SBC# 166/054-01-2023 Welding and Auto Additions
Tennessee College of Applied Technology - Hohenwald
Hohenwald, Lewis County, Tennessee

RE: Bidding Document Clarifications #2

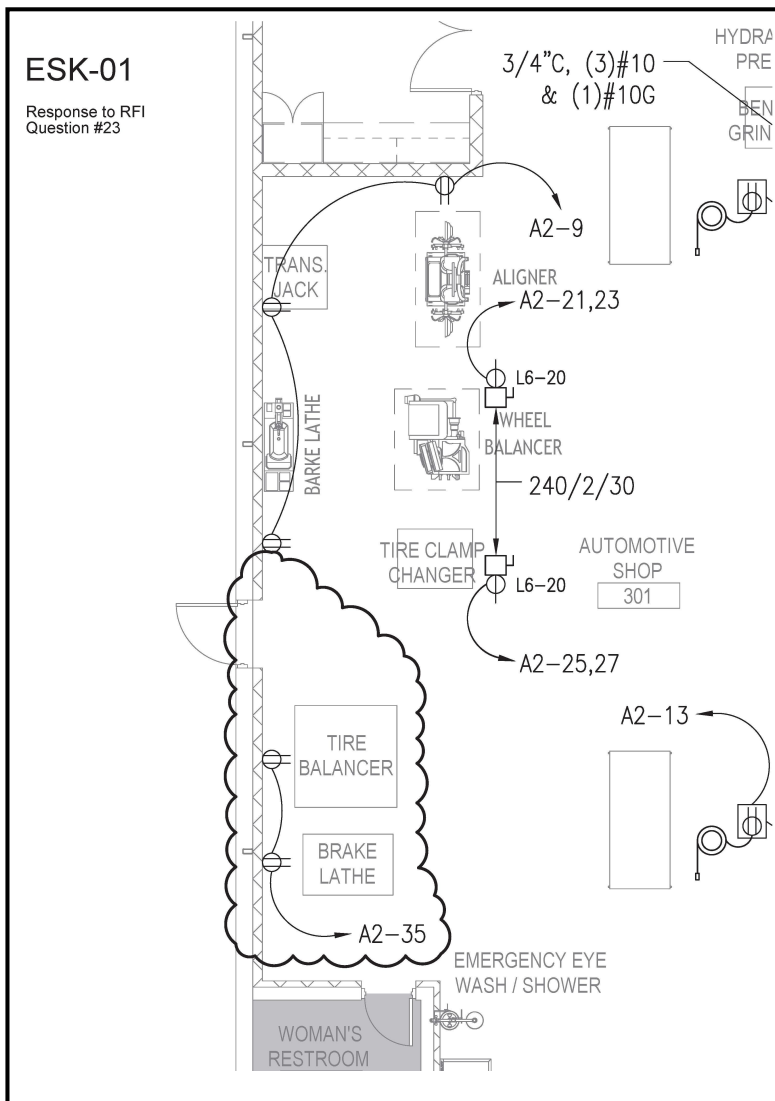
21) RFI 21: Sheet E-103 - Confirm power feeds for aligner, brake lathe x2 and tire balancer do not require new dedicated circuits / disconnects.

Response: Aligner is mobile and will use cord reel at lift. Split existing circuit on wall as indicated in sketch ESK-01 below for Brake Lathes and Tire balancer. This equipment is indicated to be 120V/20A plug type.

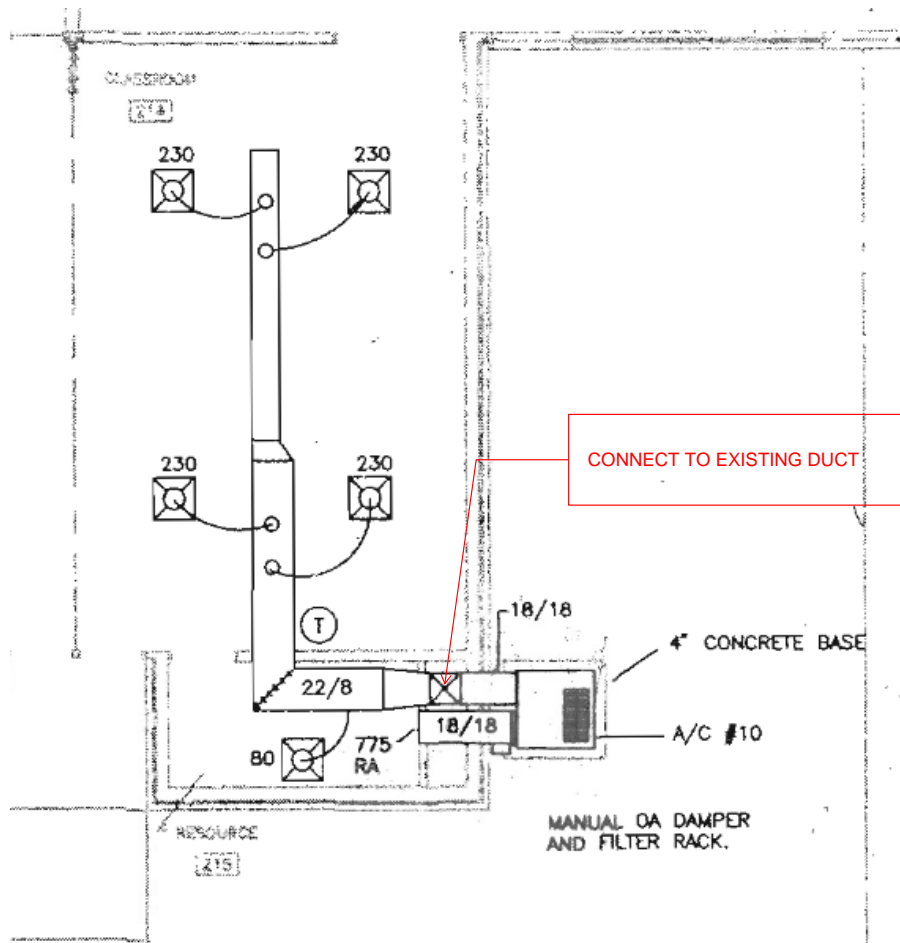
22) RFI 22: Sheet M-102 - AC-10 needs to be relocated per page M-102 but the sheet does not show where it connects to the existing duct, please provide more detail.

Response: See detail below:
